**Seattle  
Design  
Commission**

**APPROVED  
MINUTES OF THE MEETING  
20 March 2003**

Projects Reviewed

Preferred alternative concept plan.

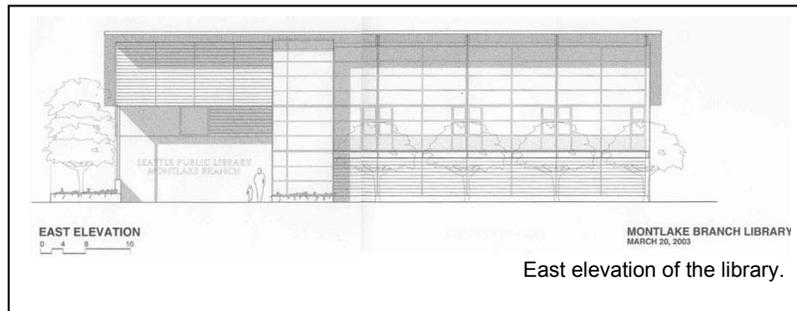
- Is concerned that patrons who cannot climb the stairs must go in and around the corner behind the lobby to enter. Encourages the team, on the east elevation, to show parking and landscape, like the retaining wall height, to show that they fit. Urges proponents to look to the railing outside of Benaroya Hall for an example of a railing along a sidewalk.

- Is concerned that when a person is driving they will not perceive the corner of the library.
  - Proponents stated that they should be able to through the L-shaped window.

- Proponents stated that they are pressured by the garage and could perhaps let the stair inflect and get wide at the bottom.
- Feels that the entry needs to be a broader gesture and needs to connect with the circulation desk. Would like to see the roof overhang vary in width.

Boren Pike Pine Park plan.

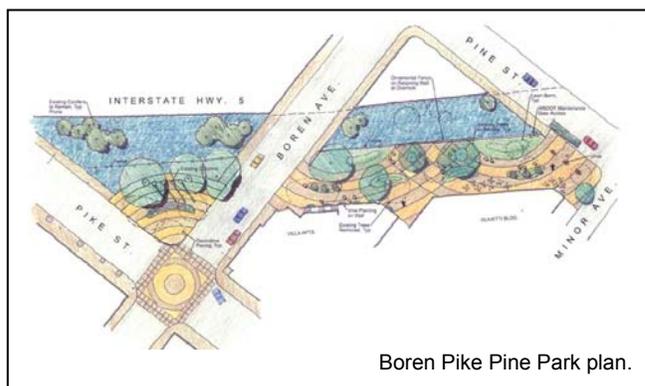
- Believes that, overall, this is a huge improvement on the previous scheme. Last time the Commission had suggested a simplification of the scheme and this plan is simple. Suggests the team explore reversing the placement of the berms and open space so that it is open along the freeway and the berms are against the building. Recognizes that there are social problems and urges proponents to do the best they can and not let these problems compromise the park design. Also recommends that the little bits of green be eliminated.

- Feels that the biggest problem with the plan is on the ground because the pattern will be hard to read when there. Suggests using a totem idea and have large trees or some vertical element on either side so eye is drawn between the two.

- Proponents stated that one of the buildings that is currently a garage will change and won't be a hard line wall. It is going to be developed into retail space.
